MSOS404A-03D

Modification Recommended Service Note

MSOS404A – MSO Infiniium S Series 4GHz 4 channel

The Problem – Under certain circumstances a PLL2 error may occur on the S-series products.

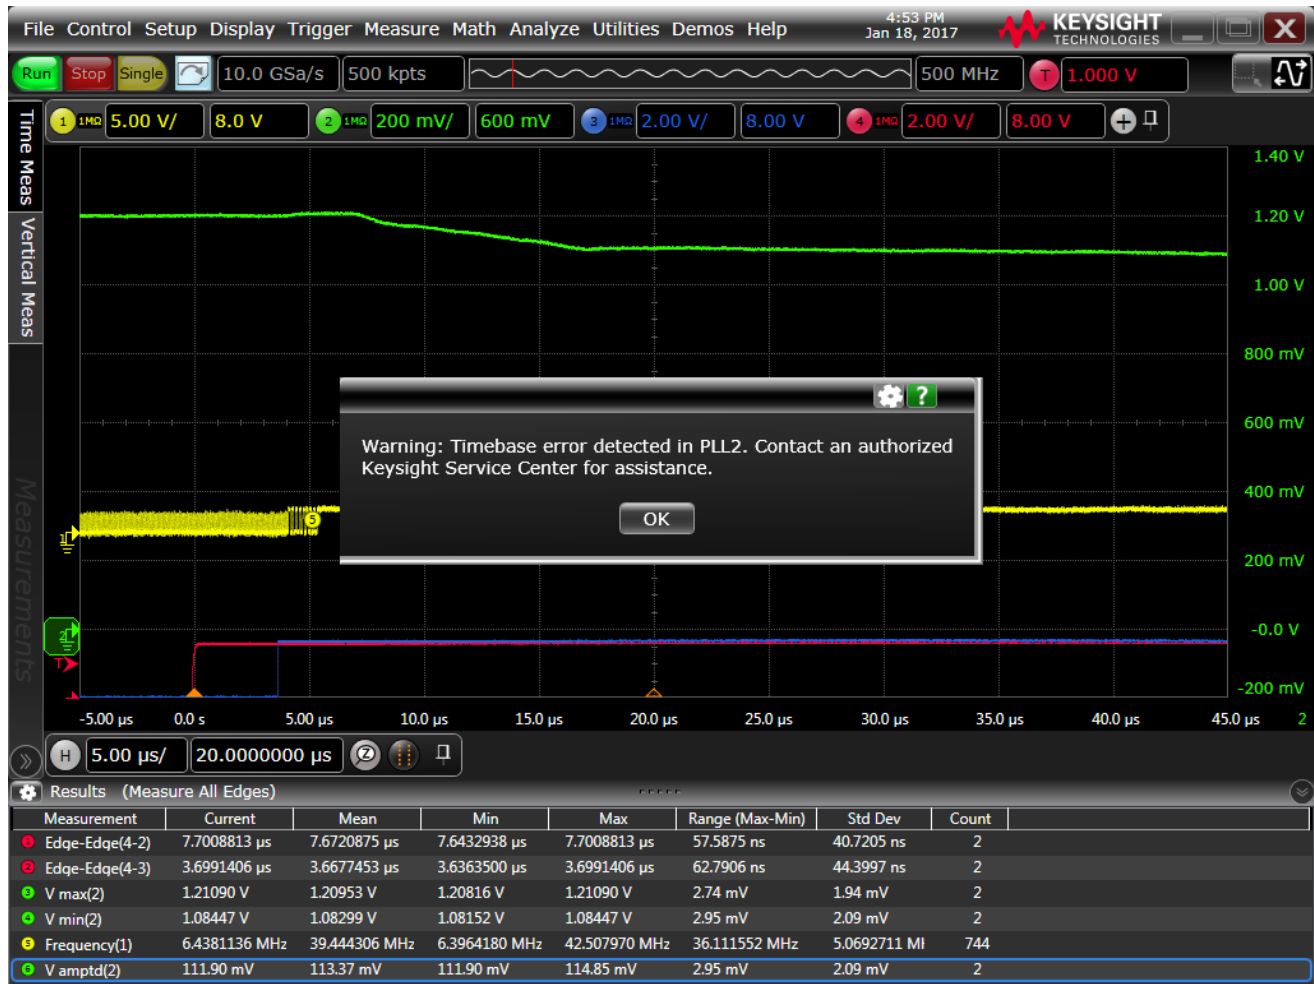
On older acquisition boards a PLL2 error message sometimes occurs. The error message appears on the screen as below:

There are new acquisition boards that fix this issue for the S-series scopes.

1. If the customer needs to have software revision < 6.10.01001, then replace the acquisition board with the 54911-69532 board.
2. If the customer can have software revision >= 6.10.01001, then it can be replaced by any of these three boards: 54911-69521, 54911-69531, or 54911-69532.
3. Save the Serial Numbers of the replaced and the new Acquisition Boards in Siebel. Please, follow this procedure:
 - a. For each Service Order in Siebel, there is a tab labeled Activities:
